SP2023-028: Site Plan for a Warehouse/Office Development at 1760 Airport Road

PROJECT NUMBER: SP2023-028  
PROJECT NAME: Site Plan for 1760 Airport Road  
SITE ADDRESS/LOCATIONS: 1760 AIRPORT RD

DEPARTMENT	REVIEWER	DATE OF REVIEW	STATUS OF PROJECT
PLANNING	Ryan Miller	08/23/2023	Approved w/ Comments

08/23/2023: SP2023-028; Site Plan for 1760 Airport Road

PROJECT No. 23420.02 SHEET No. A0.3

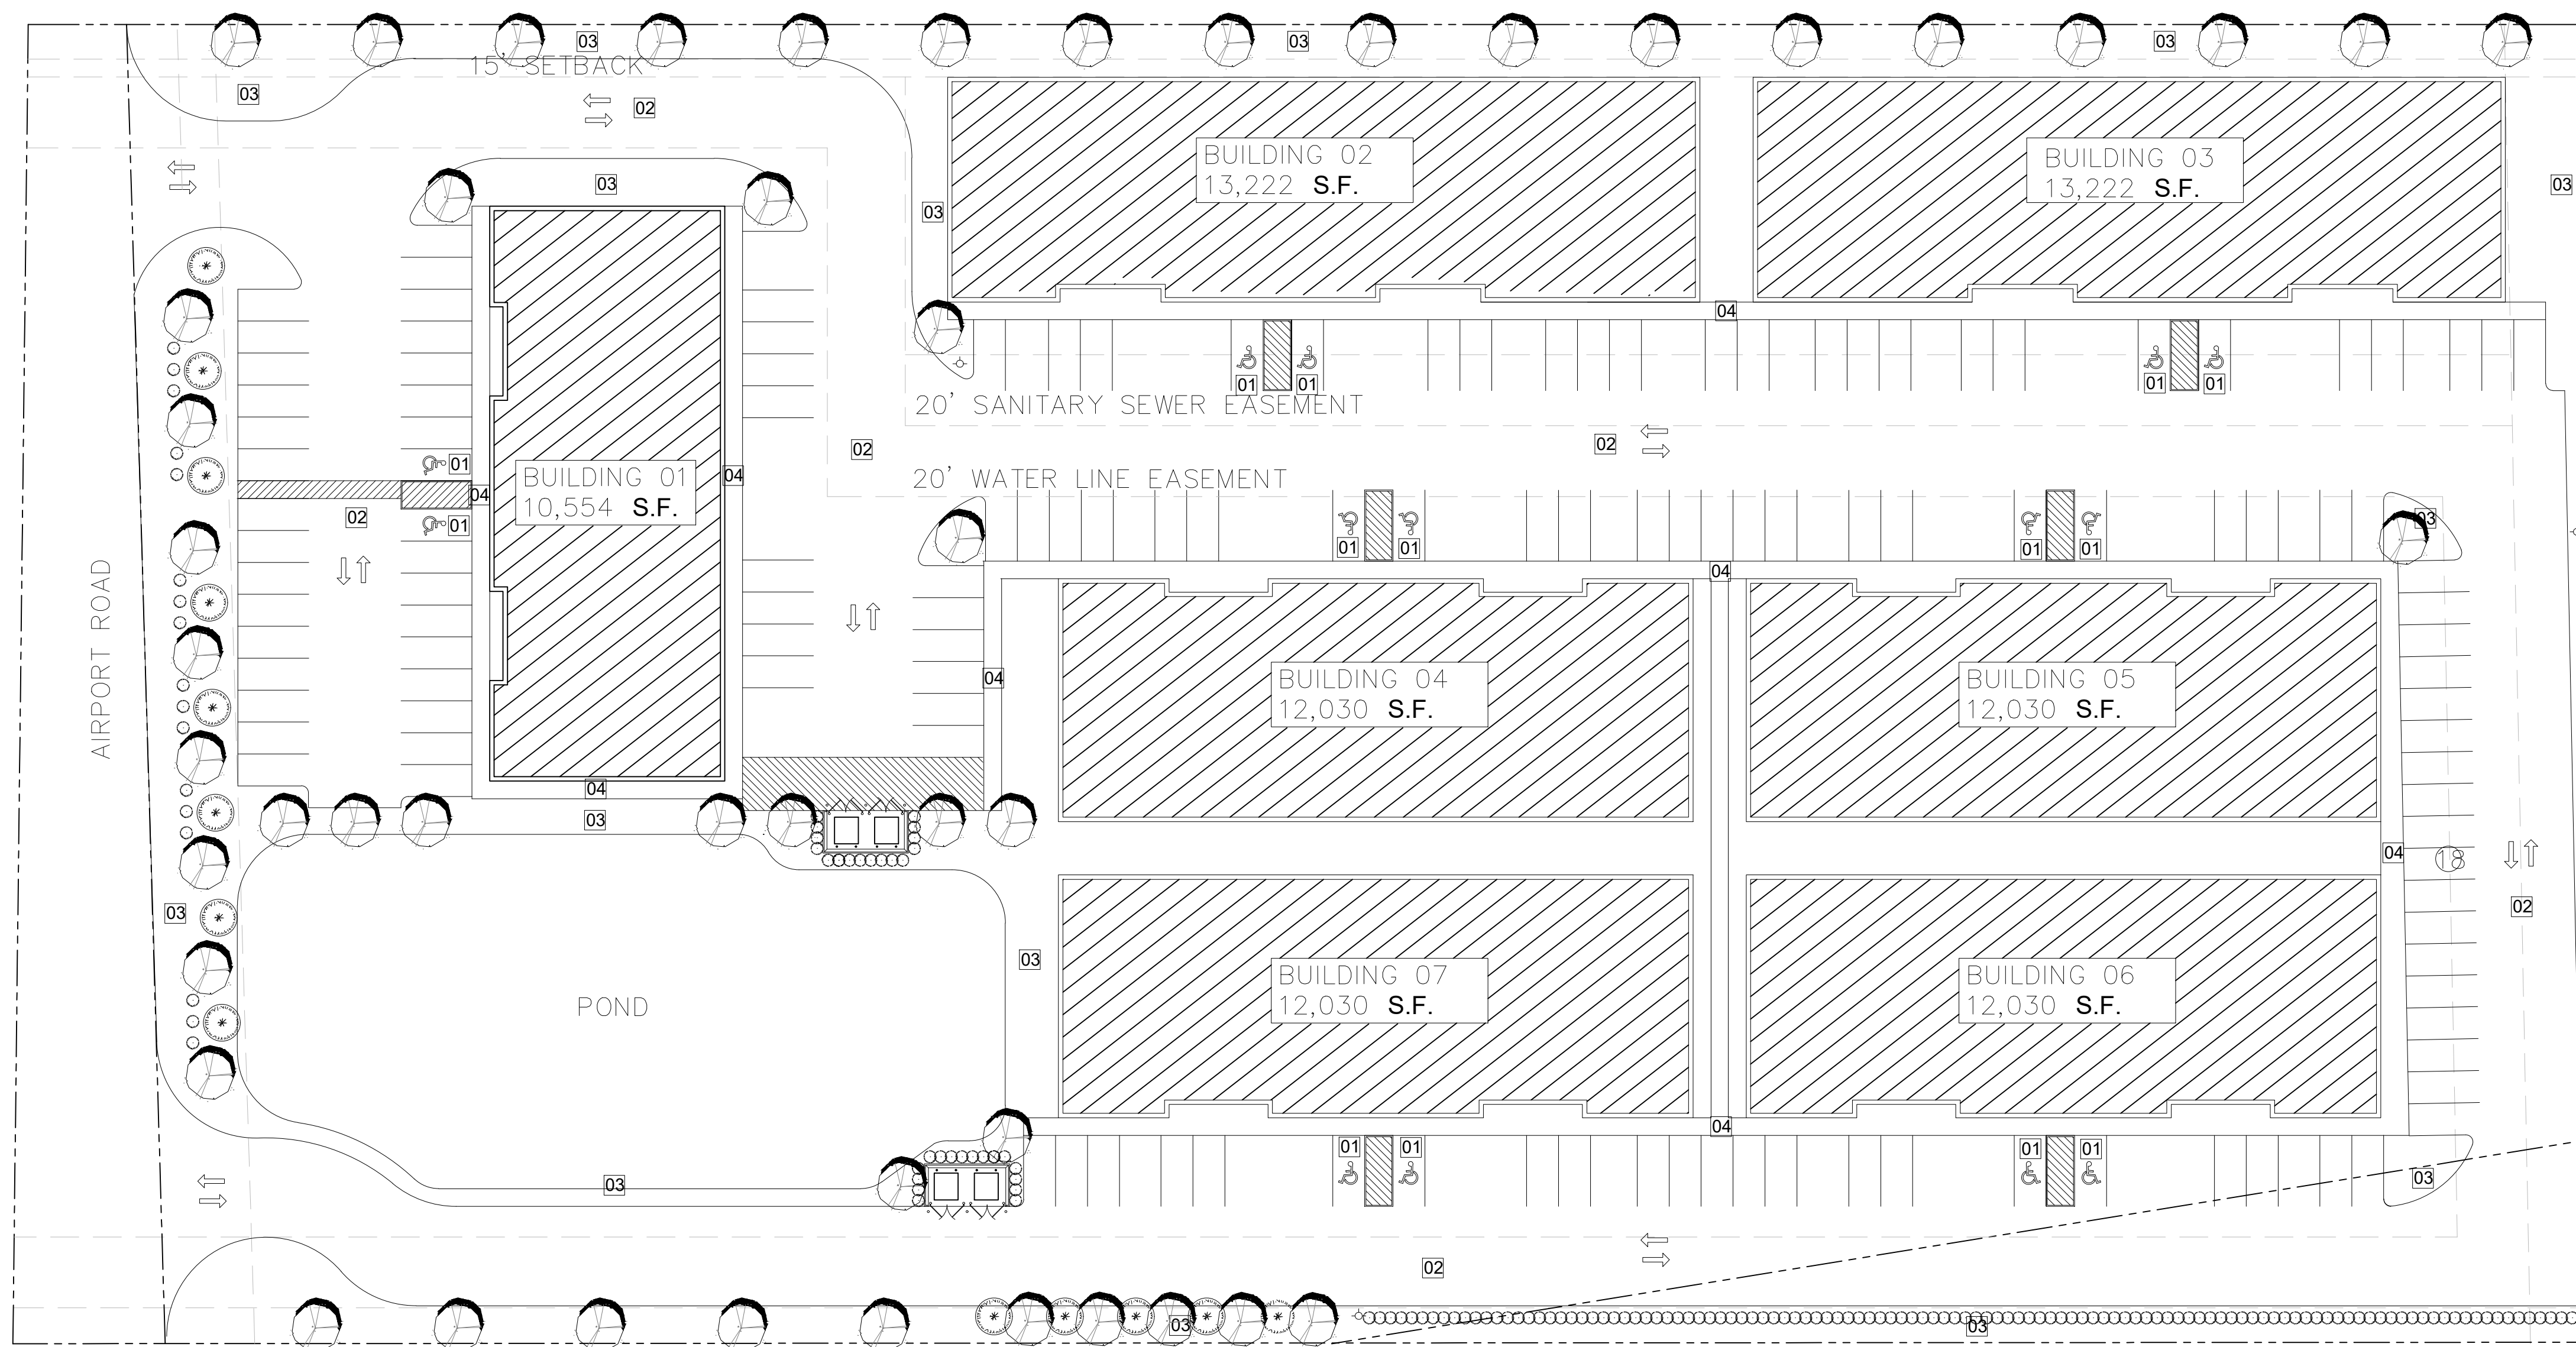
- No trees to be with 10' of any public water, sewer or storm line that is 10" in diameter or larger.
- No trees to be with 5' of any public water, sewer, or storm line that is less than 10".
- Landscape plan A0.3 remove all trees from ex. 20' water line easement.

PROJECT No: 23420.02 SHEET No: A0.3

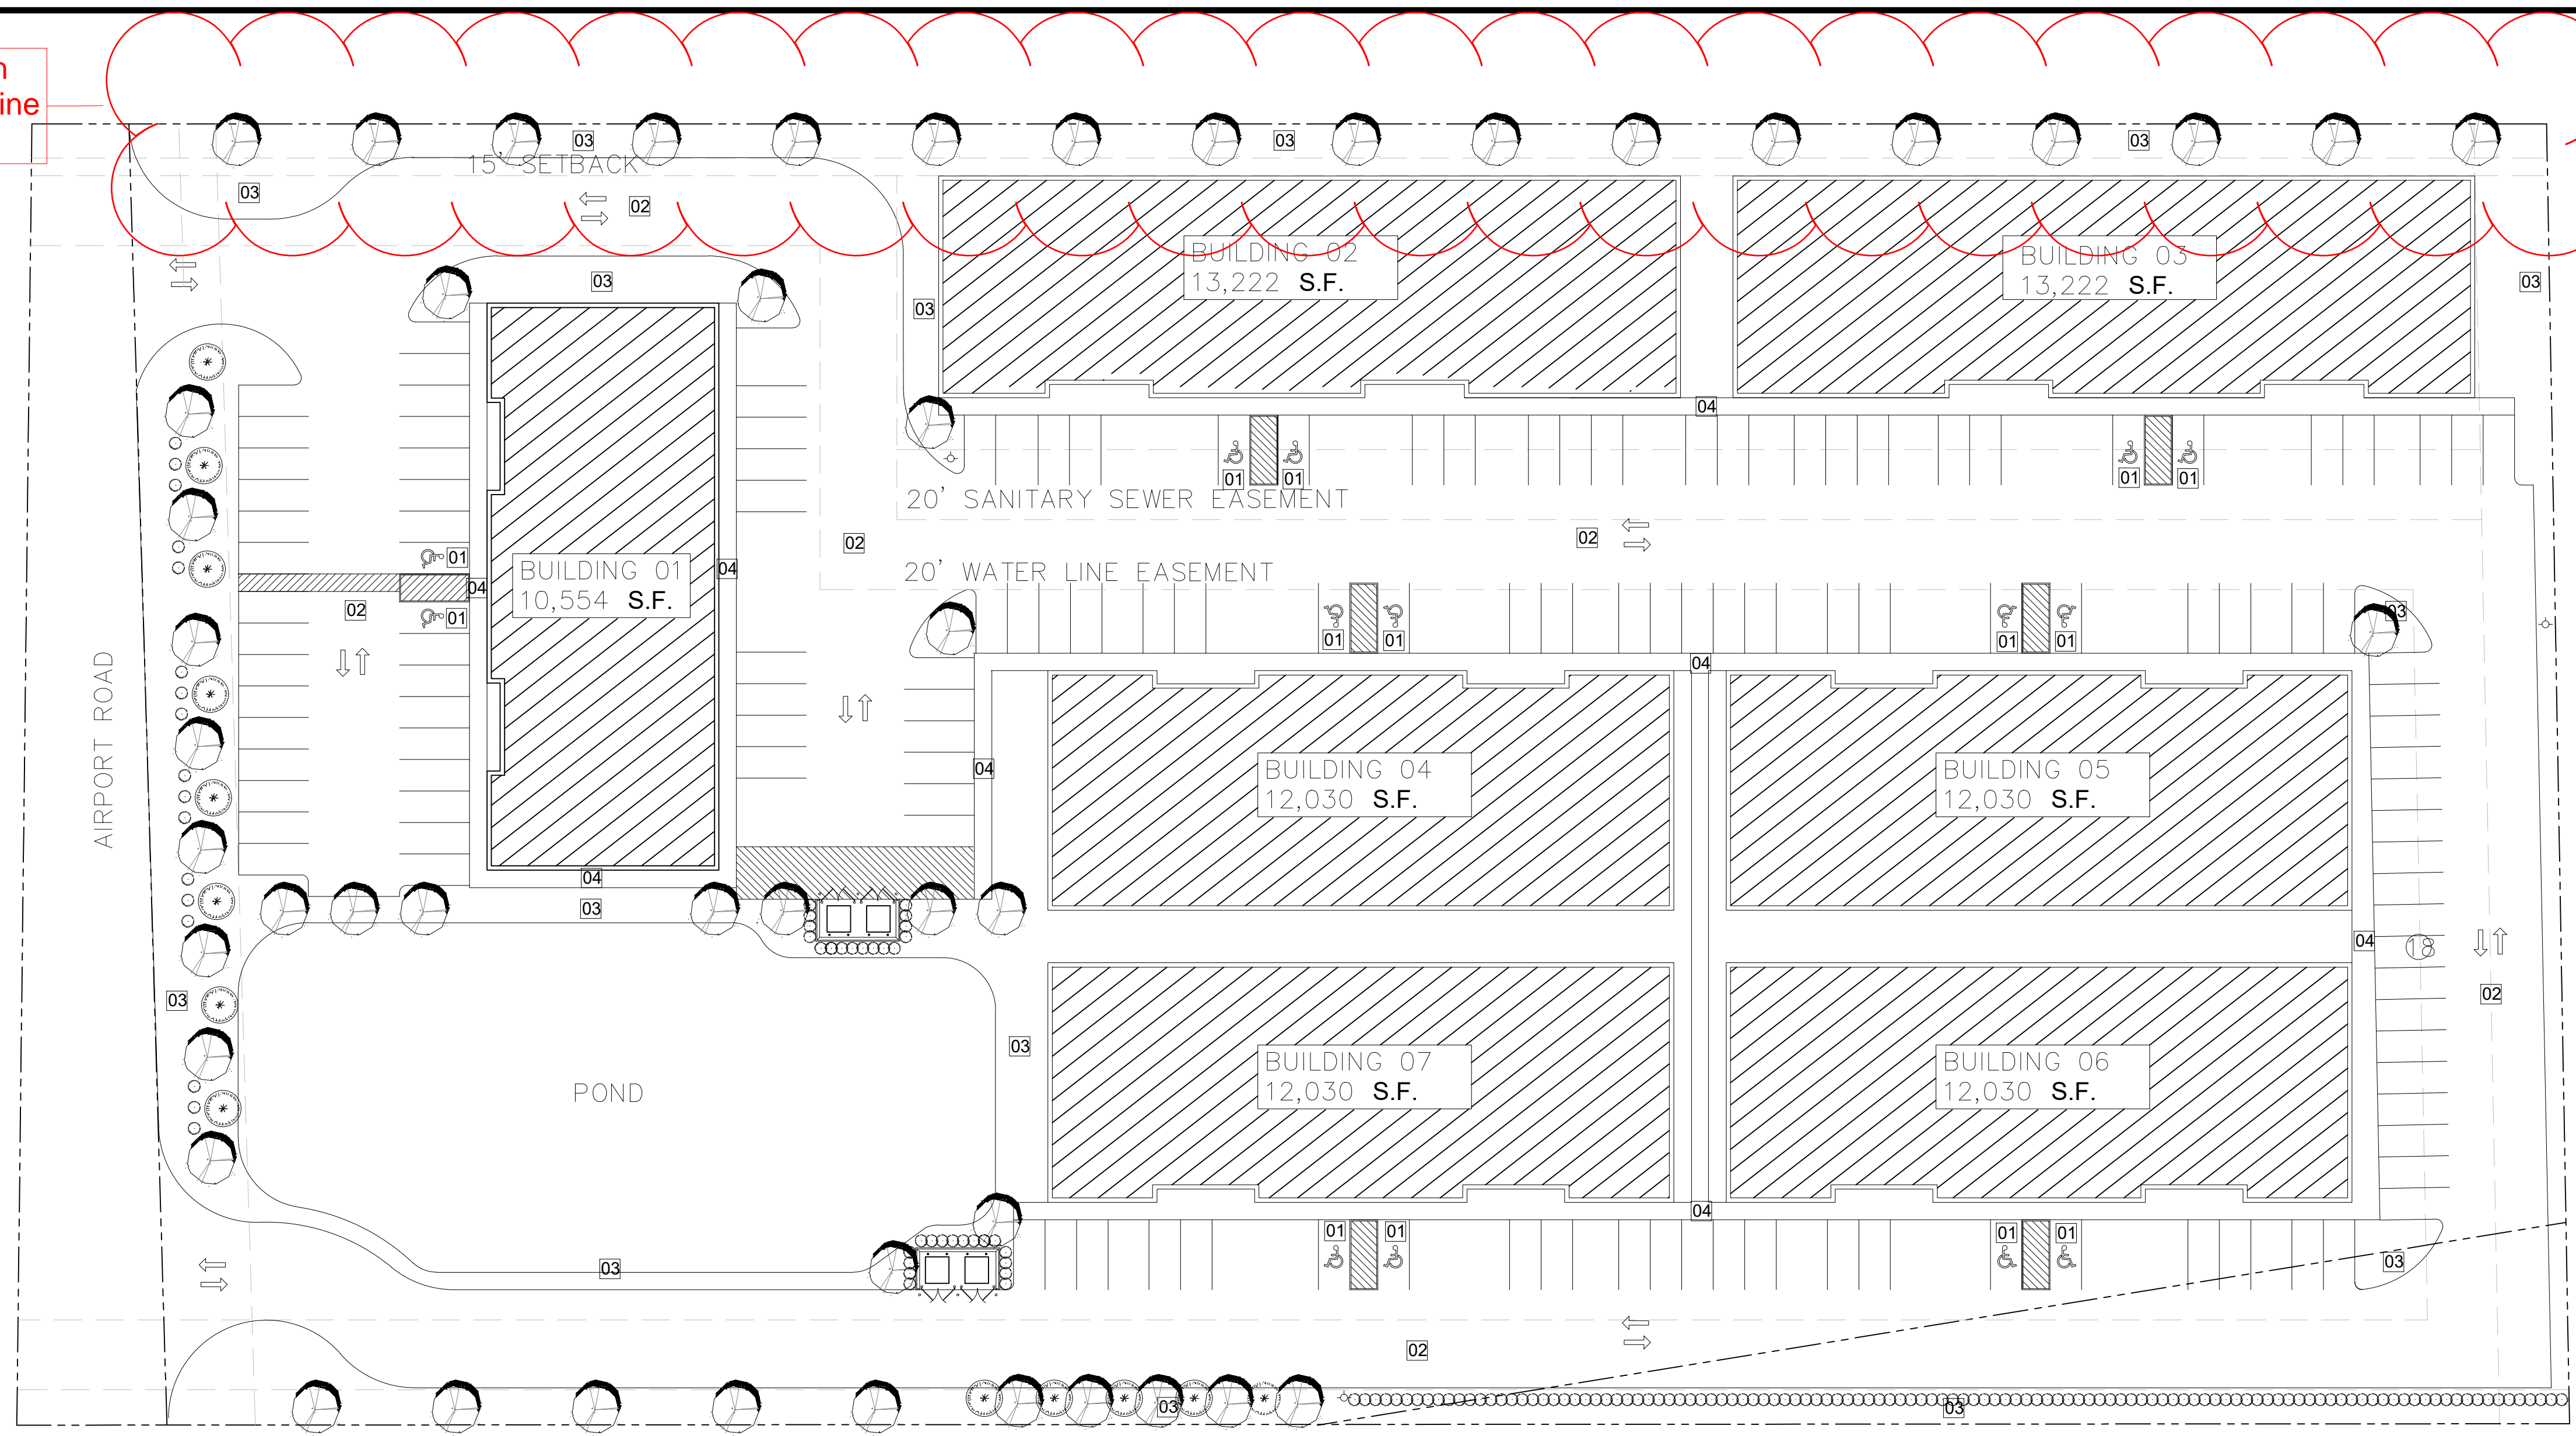
- No trees to be with 10' of any public water, sewer or storm line that is 10" in diameter or larger.
- No trees to be with 5' of any public water, sewer, or storm line that is less than 10".
- Landscape plan A0.3 remove all trees from ex. 20' water line easement
